Drain: RESERVE AT SPRINGMILL DRAIN **Drain #:** 273
Improvement/Arm: RESERVE AT SPRINGMILL - SECTION 4
Operator: JDH **Date:** 2-23-04
Drain Classification: Urban/Rural **Year Installed:** 1994

RE: The Reserve @ Springmill Drain-Section 1 Arm

RE: Reserve at Springmill Drain-Section 1

**STORM SEWER
RECORD DRAWING**

STORM SEWER PLAN

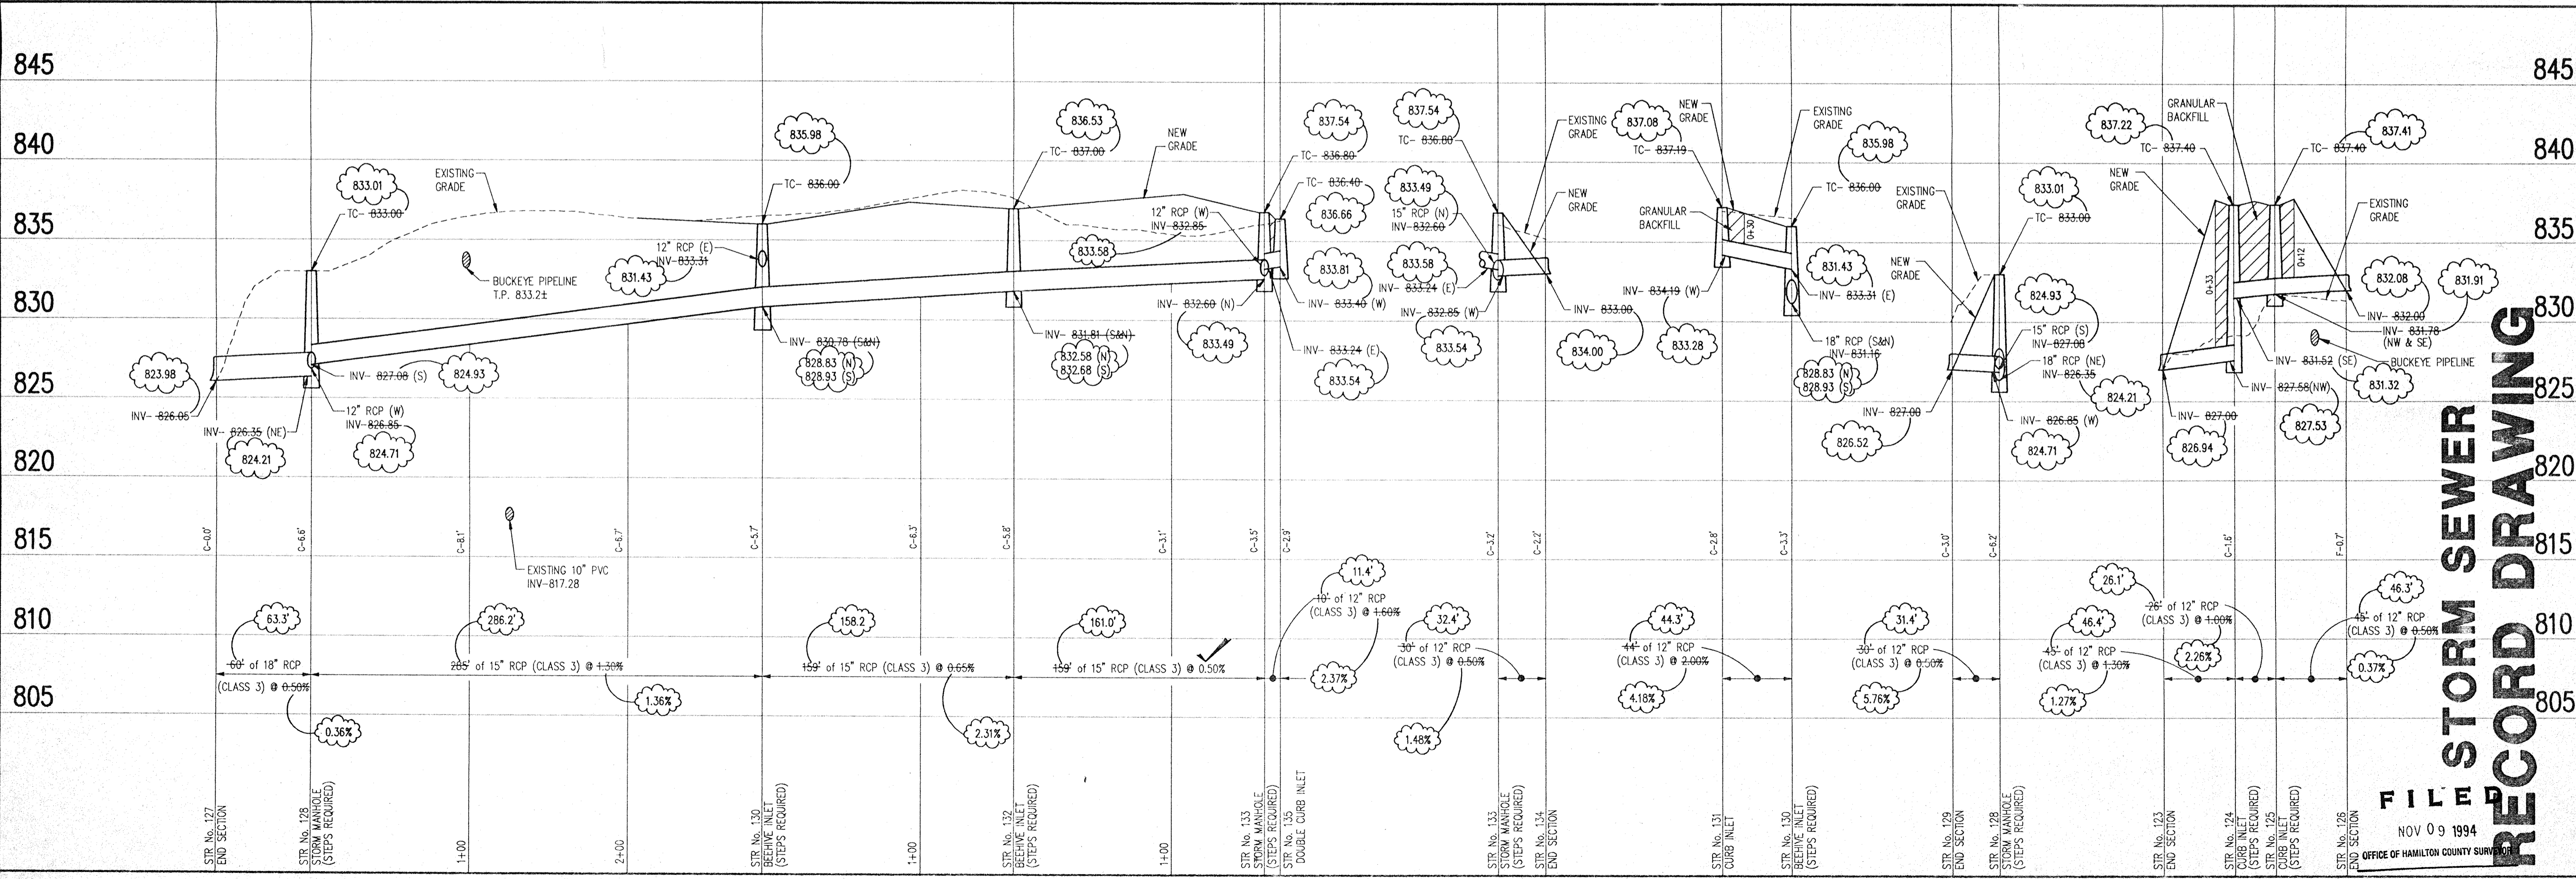
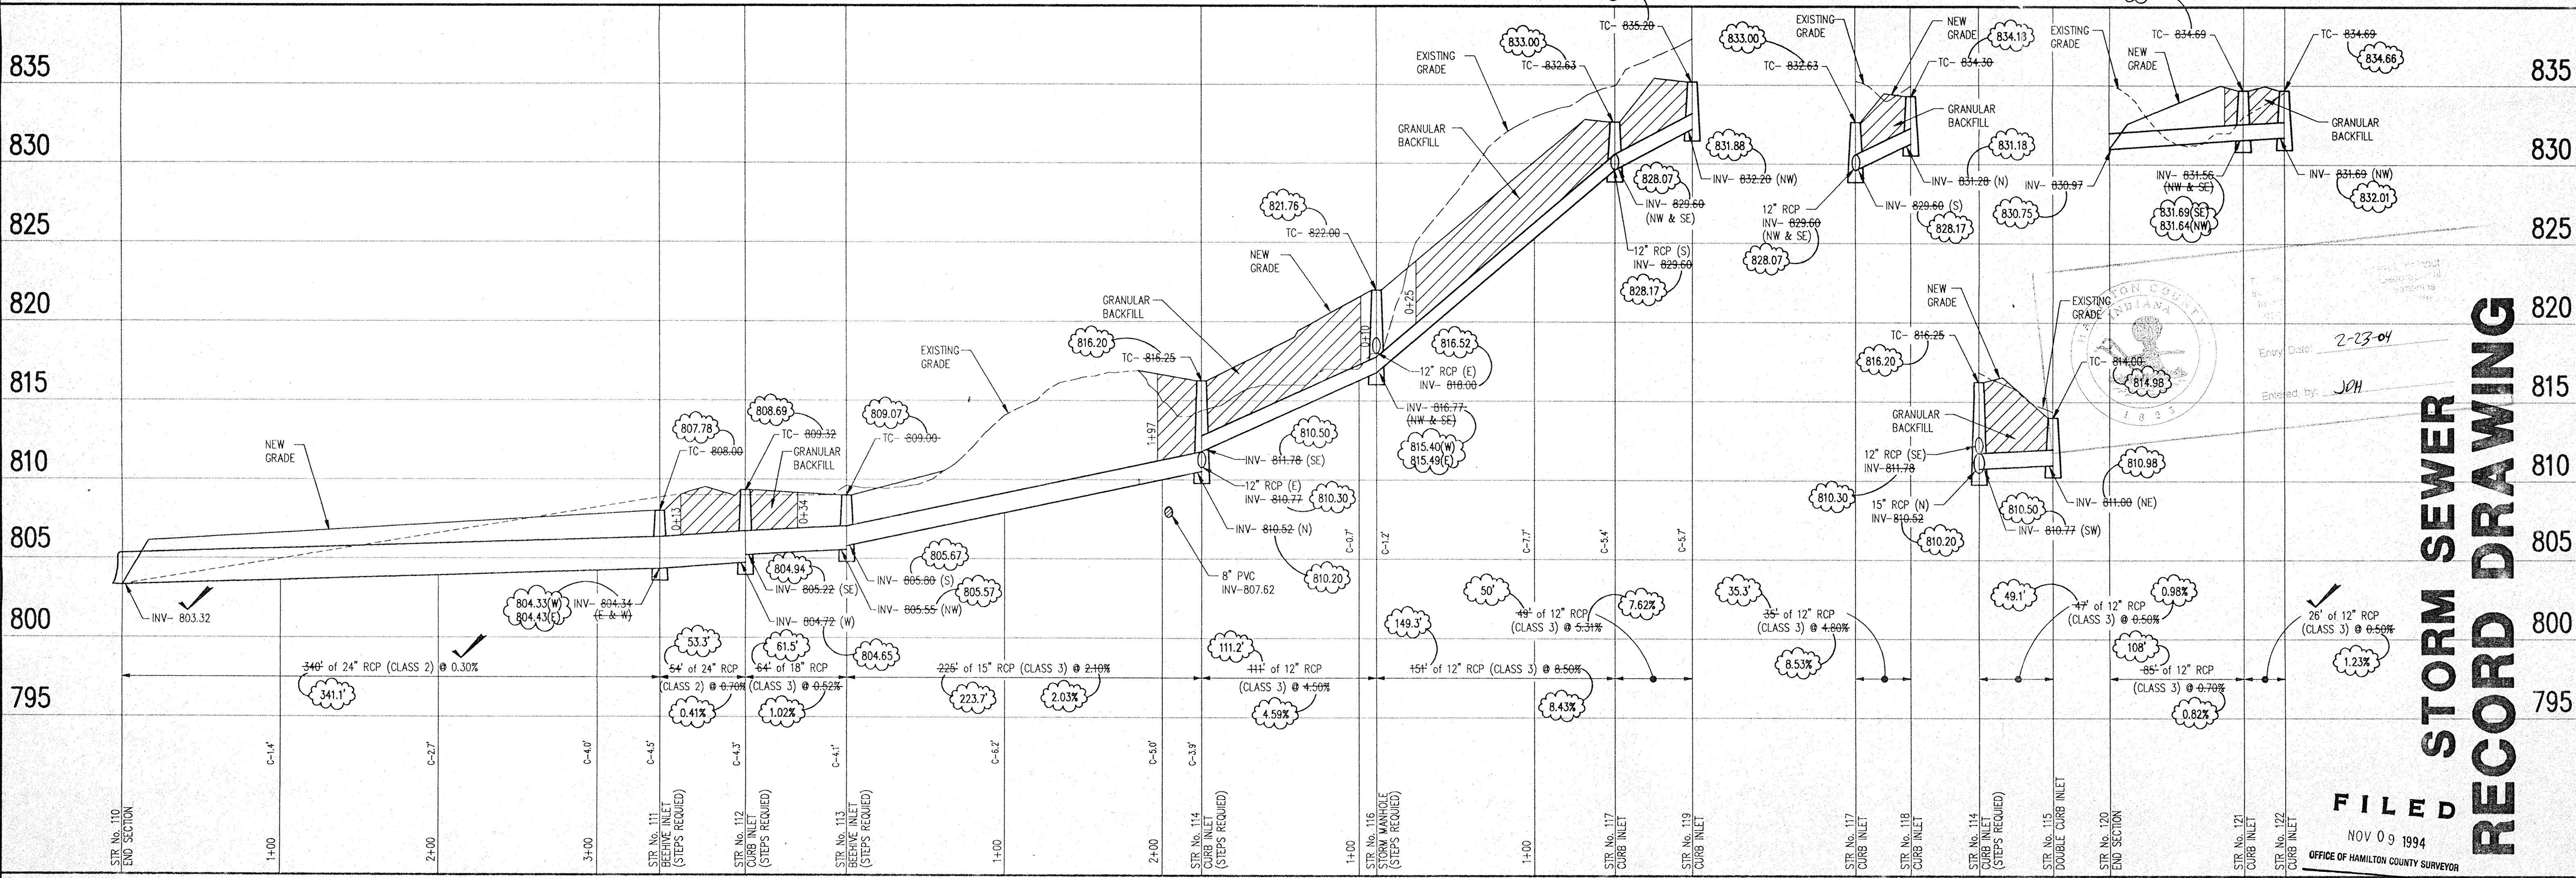
During construction, changes were made to the drain which will alter the plans submitted with my report for this drain dated October 30, 1994. The changes are as follows:

The 6" SSD was incorrectly noted on the original report. The correct total of 6" SSD is 4,734 feet. STR 132 to 130 was incorrectly noted as an 18" RCP at 159 feet. STR 132 to 130 consist of 15" RCP at 158 feet. STR 128 to 130 was incorrectly noted as 18" RCP at 285 feet. STR 128 to 130 consists of 15" RCP at 286 feet. STR 127 to 128 consist of 18" RCP, which was lengthened from 60 feet to 63 feet. STR 132-133 consist of 15" RCP which was lengthened from 159 feet to 161 feet. STR 133 to 135 consists of 12" RCP which was lengthened from 10 feet to 11 feet. STR 133 to 134 consists of 12" RCP which was lengthened from 30 feet to 32 feet. STR 129 to 128 consists of 12" RCP which was lengthened from 30 feet to 31 feet. STR 123 to 124 consists of 12" RCP which was lengthened from 45 feet to 46 feet. STR 125 to 126 consists of 12" RCP which was lengthened from 45 feet to 46 feet. STR 110-111 consists of 24" RCP which was lengthened from 340 feet to 341 feet. STR 112 to 113 consists of 18" RCP which was shortened from 64 feet to 61 feet. STR 113 to 114 consists of 15" RCP which was shortened from 225 feet to 223 feet. STR 116 to 117 consists of 12" RCP which was lengthened from 149 feet to 151 feet. STR 117 to 119 consists of 12" RCP which was lengthened from 47 feet to 49 feet. STR 114 to 115 consists of 12" RCP which was lengthened from 47 feet to 49 feet. STR 120 to 121 consists of 12" RCP which was lengthened from 85 feet to 108 feet. Str 111 to 112 consists of 24" RCP which was lengthened from 53 feet to 54 feet.

The length of the drain due to the changes described above is now 7,144 feet.
